Addendum Number 3

Lake Peachtree Spillway Replacement Project

August 4, 2017

C SEGMENT I1 INFILL BASE 1 SECTION

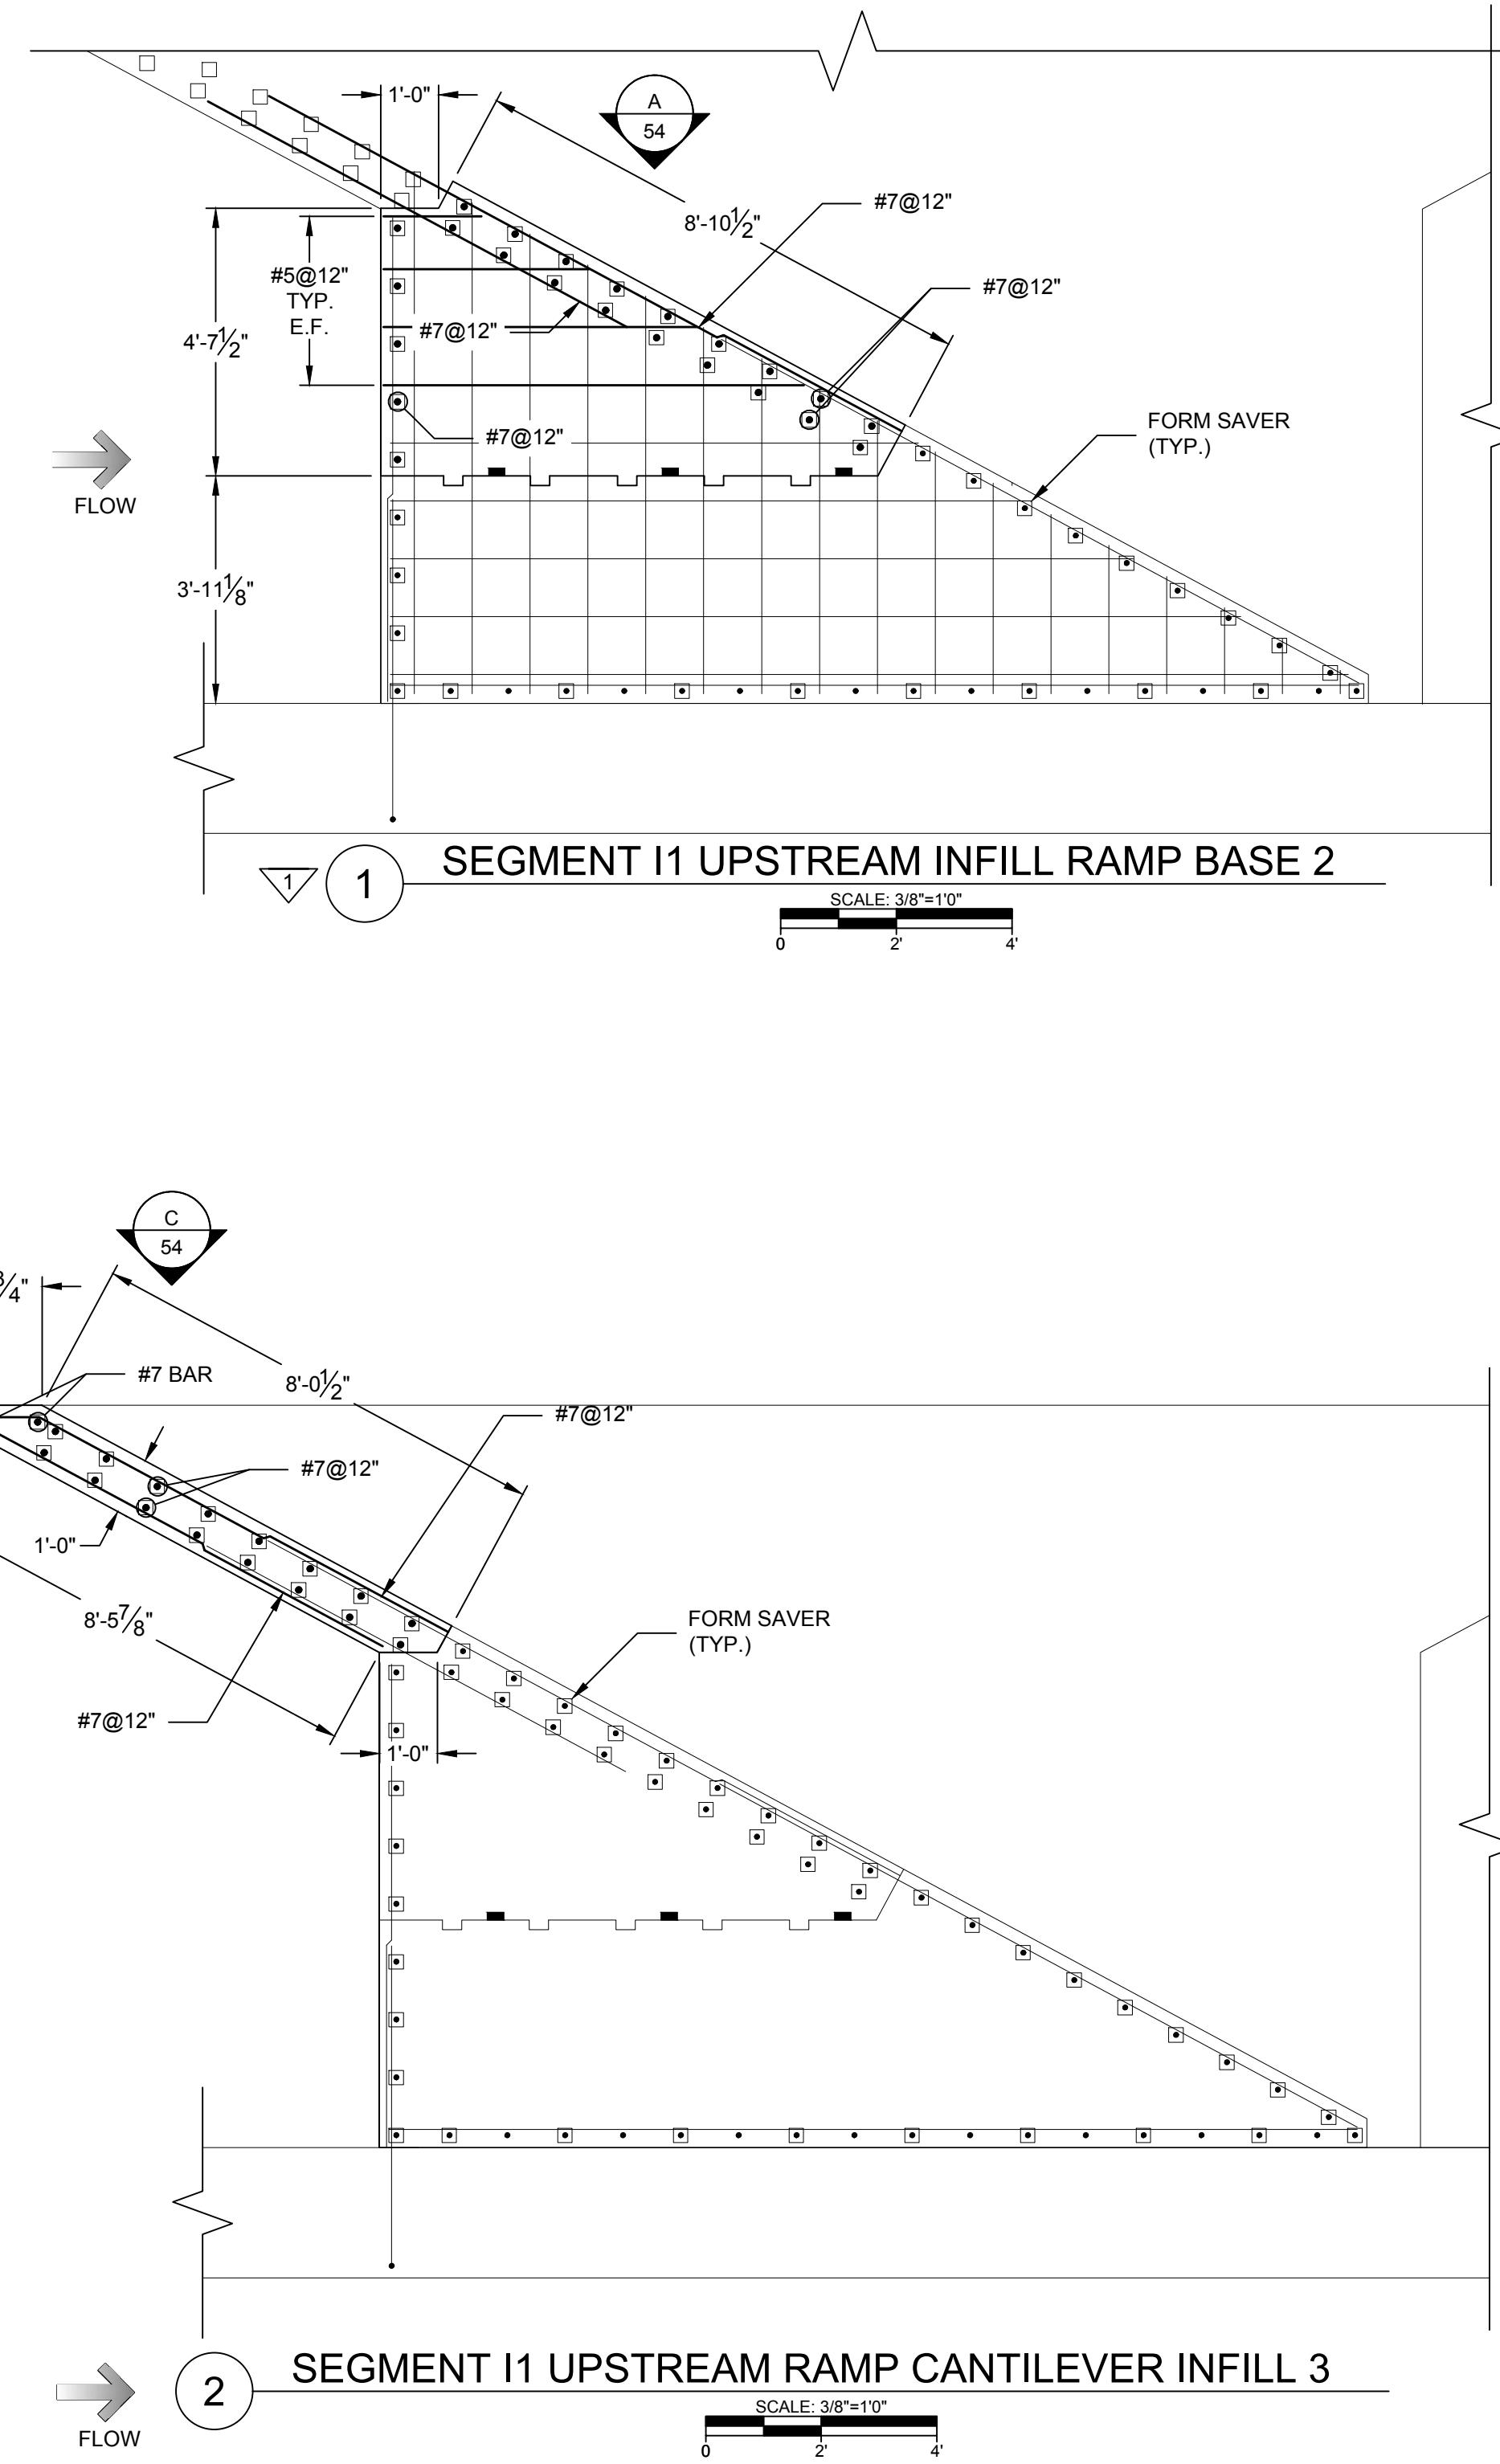
Note: The upstream ramp support walls (Sheets 37, 48, 53) were revised to include a 12-inch radius to improve hydraulic efficiency on the upstream ends of those walls.
